CITY OF SACRAMENTO PLANNING COMMISSION
 1231 "I" STREET, SUITE 200, SACRAMENTO, CA 95814

- APPLICATION:**
- A. Negative Declaration.
 - B. Rezone of 5.44± vacant acres from Standard Single Family - Review (R-1-R) to Single Family Alternative (R-1A) zone.
 - C. Tentative Map (Beth Estates) to subdivide 5.44± vacant acres into 35 single family parcels in the proposed Single Family Alternative (R-1A) zone.
 - D. Special Permit to develop 35 single family residences.

APPLC. NO. P90-430

MEETING DATE January 24, 1991

TENTATIVE SUBDIVISION MAP BETH ESTATES CITY OF SACRAMENTO, CALIFORNIA

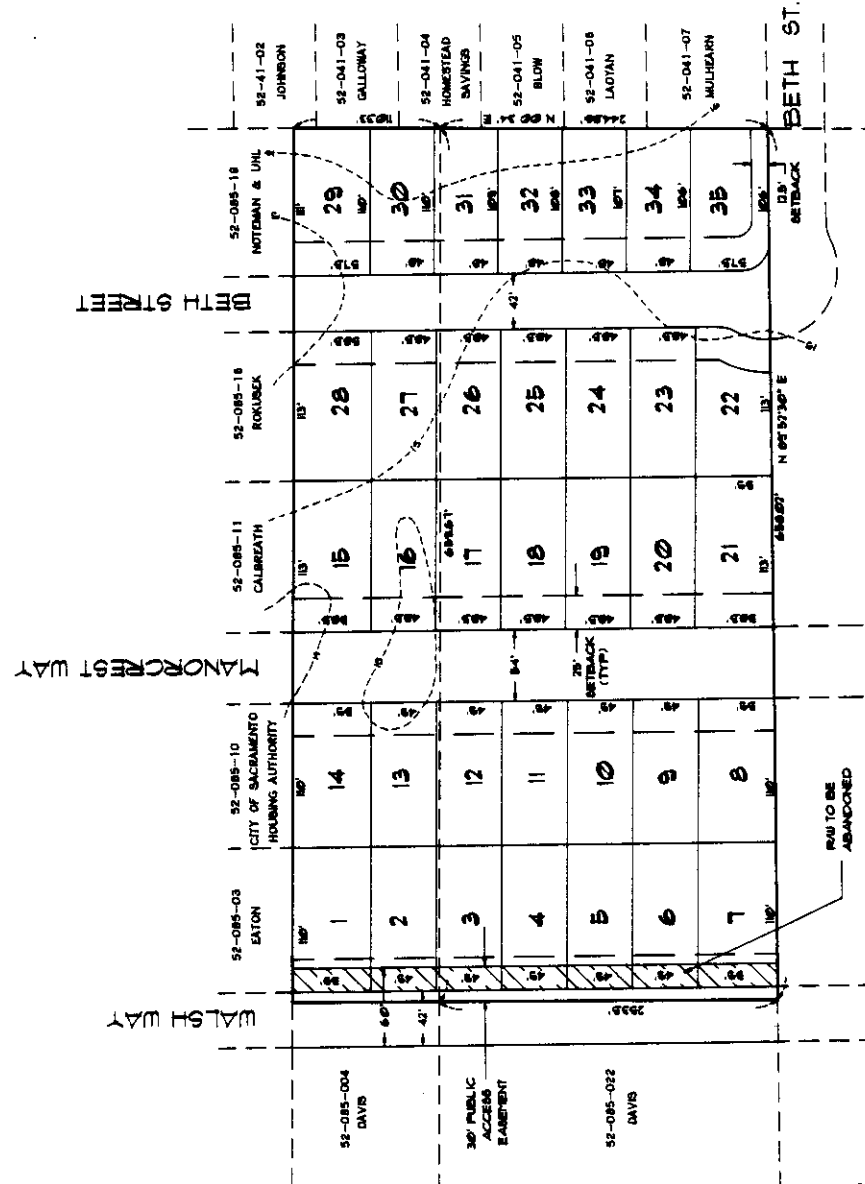
The tentative map proposes to divide the 5.44± acres into 35 parcels. The lots range between 48 feet and 59 feet wide. These widths are acceptable for an R-1A zoned property. There are some off-site dedications required for connections of Walsh Way and Manorcrest Way within the North Shores Subdivision. Temporary connections or turn-arounds are necessary until the development of North Shores occurs. Staff has no objection to the tentative map proposal provided the conditions listed below are met.

- 1. Provide standard subdivision improvements pursuant to Section 40.811 of the City Code including a 12 foot paved lane southbound on Walsh Way;
- 2. Prepare a sewer and drainage study for the review and approval of the City Engineer. Drain study required off-site extension, oversizing and possible pump station;

- 8. Dedicate the north 5 feet of lots 1, 14, 15, 28, and 29 as a public utility easement for overhead and underground facilities and appurtenances;

9. Dedicate the east 5 feet of lots 29 through 35 as a public utility easement for overhead and underground facilities and appurtenances;
10. Dedicate right-of-way along Beth Street and Walsh Way to 44 feet as per study on file with the City;

13. Requires off-site dedication along Walsh Way and connection between Walsh Way and Manorcrest Way and connection of Beth Street;
14. Developer shall provide a temporary connection between Walsh Way and Manorcrest Way with a minimum 20 feet of paving, or a temporary turn-around at the end of Walsh Way and Manorcrest Way, to the satisfaction of the Traffic Engineer;

15. Show all existing easements on final map;
16. Developer shall provide curbs, gutters and sidewalks and paving on the north side of the connection at Beth Street, and a minimum of 12 feet of paving eastbound; and

ELEVATIONS
PLAN 1 BETH ESTATES
CITY OF SACRAMENTO OCT. 1990
SCALE: 1"-1/8"

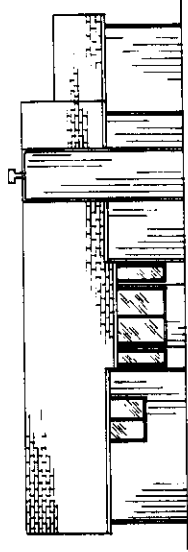
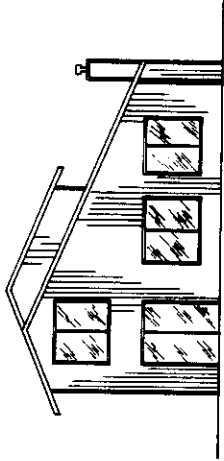
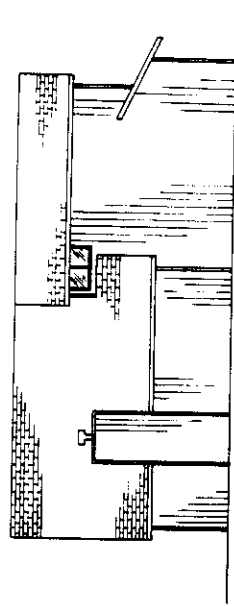
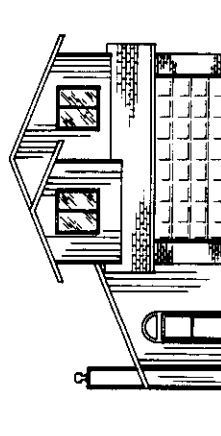
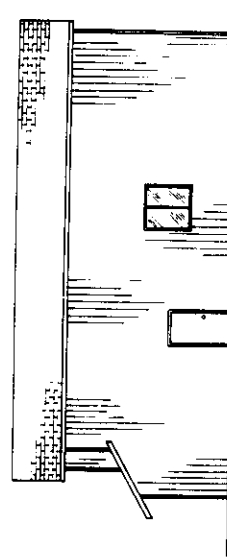
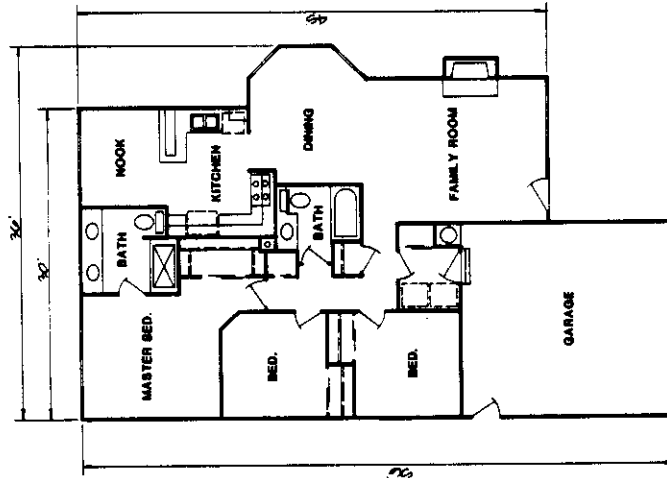
The proposed elevations consist of T1-11 siding with masonry trims. Staff suggests the applicant revise the elevations and submit for review and approval of Design Review Staff prior to the issuance of Building Permits. The revised elevations should include a more pronounced entrance for the units and increasing the windows on some of the elevations, specifically the east and west elevations of Plan 2. The revised elevations should, in a very detailed fashion, specify the type of materials to be used. T1-11 is a building material that requires careful consideration. The adequacy of architectural features will determine the appropriateness of whether it will be an acceptable material. The revised elevations should specify the masonry trim materials as well as window and door trims. The roof material is also important. Generally, laminated dimensional composition shingles with a minimum 25 year rating are suggested. Staff also suggests metal garage doors with raised panel design. Special attention should be paid to building design on the corner lot (Lot 35) of the subdivision.

1. The applicant shall submit a master site plan showing which of three units will be located on each lot with the setbacks to be provided, for review of the Planning Director prior to the issuance of Building Permits. The front setbacks should range from 25 to 30 feet.
2. The applicant shall submit revised, detailed, elevations for review and approval of Design Review Staff prior to the issuance of Building Permits. Design Review Staff shall address, at a minimum, the exterior siding material and trim, roof material, enhanced front entrance to the unit, and increased windows. The corner lot (Lot 35) shall also have an enhanced elevation for the street side elevation.
